Sony IP&S Inc.

No. HDCM18-073R-TN

## Technical News

**Subject: Software Release [V4.20 => V4.21]**

- Menu display when HDR normal speed is effective

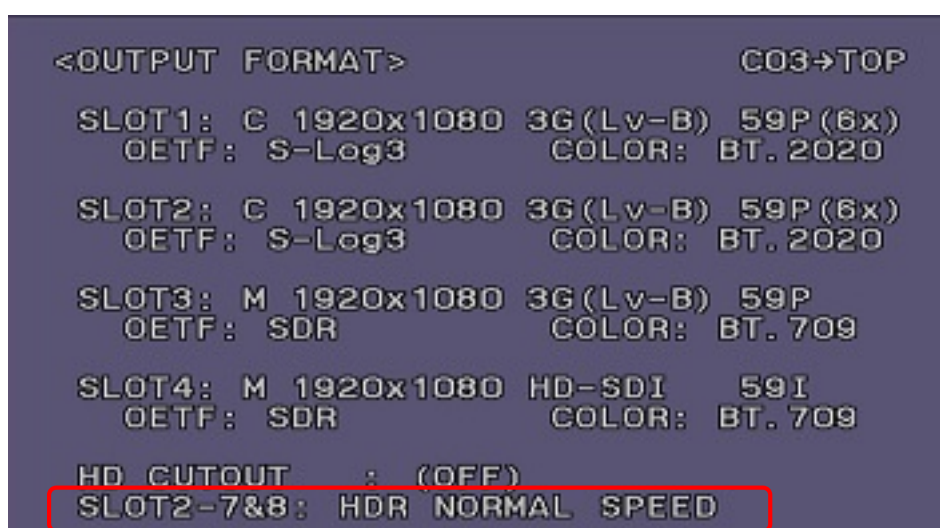
When the HDR is effective and the HDR normal speed output is effective in HD HFR format, the condition that the HDR normal speed output is effective is indicated by displaying “SLOT2-7&8 : HDR NORMAL SPEED” at the bottom of C03 OUTPUT FORMAT page.
